Well Name: SALT FLAT CC 20-29
FEDERAL COM

Well Number: 43H

Notice of Intent

Type of Action: APD Change

1. Cement Program

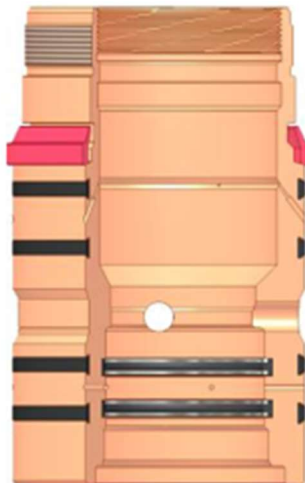
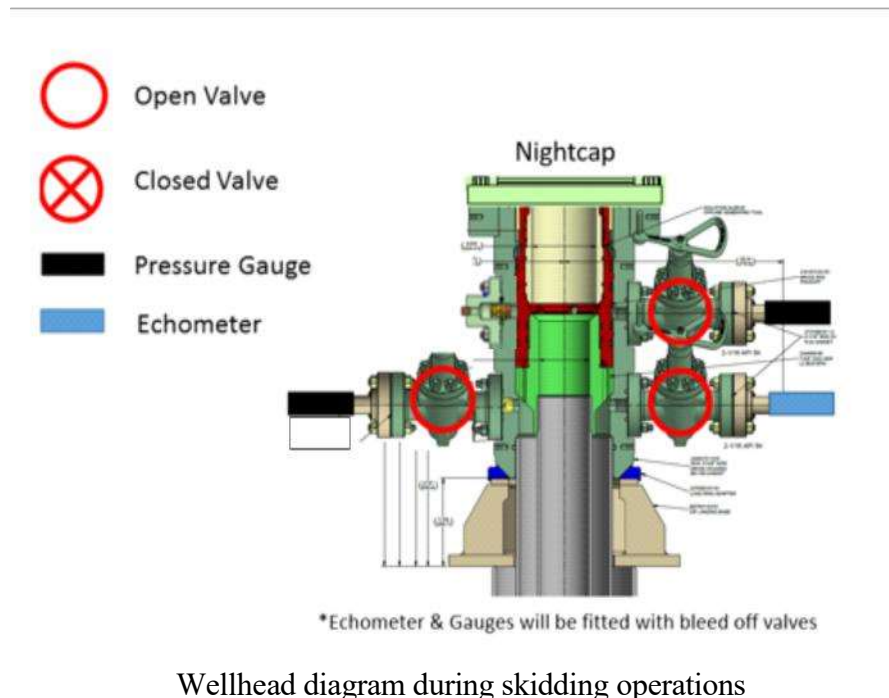
No changes to the cement program will take place for offline cementing.

Wellhead diagram during offline cementing operations

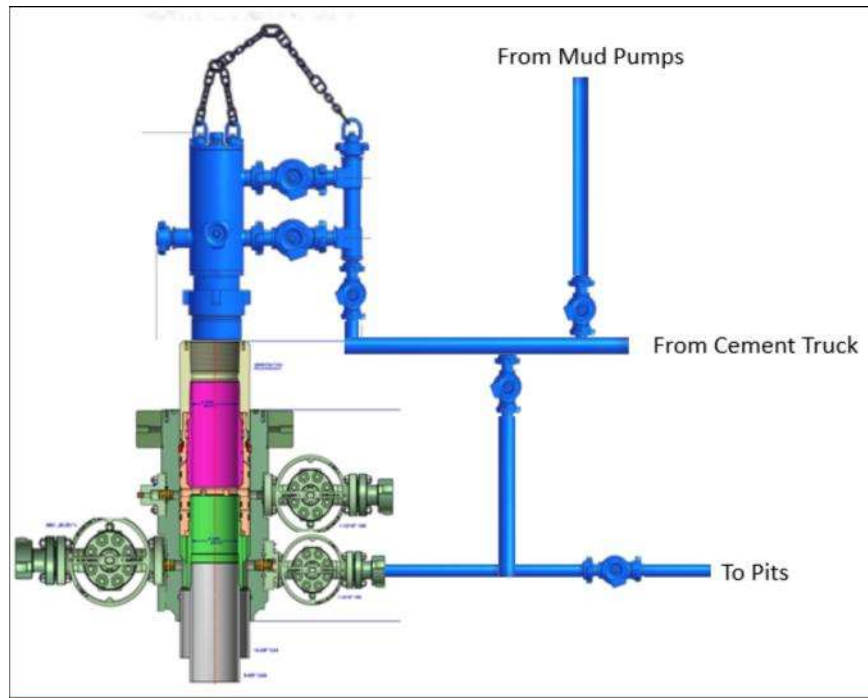
8. Install offline cement tool
9. Rig up cement equipment

10. Circulate bottoms up with cement truck
 - a. If gas is present on bottoms up, well will be shut in and returns rerouted through gas buster to handle entrained gas
 - b. Max anticipated time before circulating with cement truck is 6 hrs
11. Perform cement job taking returns from the annulus wellhead valve
12. Confirm well is static and floats are holding after cement job
13. Remove cement equipment, offline cement tools and install night cap with pressure gauge for monitoring.
